Access Compliance Report

Public Rights-of-Way

Intersection ID: 22536	Main Street: PROVIDENCE_RD	Cross Street: SUMMERTREE_LN	Location: NW
ADA ID: FDE9F6C6BF06	Ramp Type: Perp	Initial Pass/Fail: Fail	Overall Compliance: No
Severity Score: 12.5			
Codes/Mitigation Info/Possible Solution		Field Measurements/Component Compliance

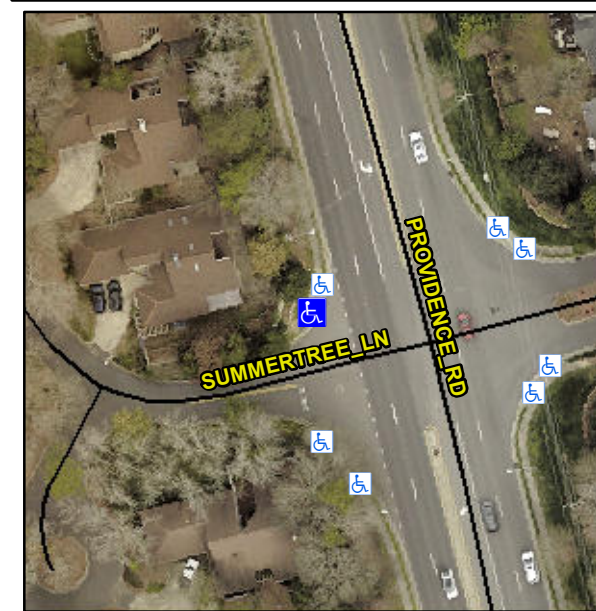
R304.2.2

Compliance	Description	Data	Compliance	Description	Data
N/A	Ramp Length (in)	73.0	No	Ramp Slope (%)	9.5
Yes	Ramp Width (in)	53.0	Yes	Ramp XSlope (%)	0.3
N/A	Flare Type LT	N/A	N/A	Flare Type RT	N/A
N/A	Flare Slope LT (%)	N/A	N/A	Flare Slope RT (%)	N/A
N/A	Flare Traversable LT?	N/A	N/A	Flare Traversable RT?	N/A
N/A	Landing Length (in)	N/A	N/A	DWS Provided?	N/A
N/A	Landing Width (in)	N/A	N/A	DWS Contrast?	N/A
N/A	Landing Slope (%)	N/A	N/A	DWS Length (in)	N/A
N/A	Landing X Slope (%)	N/A	N/A	DWS Full Width?	N/A
N/A	Landing Curb? (Y/N)	N/A	N/A	DWS Offset (in)	N/A
N/A	Shared Landing?	N/A			
N/A	Gutter Ponding?	N/A	N/A	Gutter Slope (%)	N/A
N/A	Gutter Lip Ht (in)	N/A	N/A	Gutter X Slope (%)	N/A
N/A	Painted X Walk1?	No	N/A	Painted X Walk2?	N/A
	X Walk 1 Direction	To S		X Walk 2 Direction	N/A
N/A	X Walk 1 Width (in)	N/A	N/A	X Walk 2 Width (in)	N/A
	X Walk 1 Slope (%)	2.9		X Walk 2 Slope (%)	N/A
	X Walk 1 X Slope (%)	3.2		X Walk 2 X Slope (%)	N/A

Remove & Replace Entire Ramp.
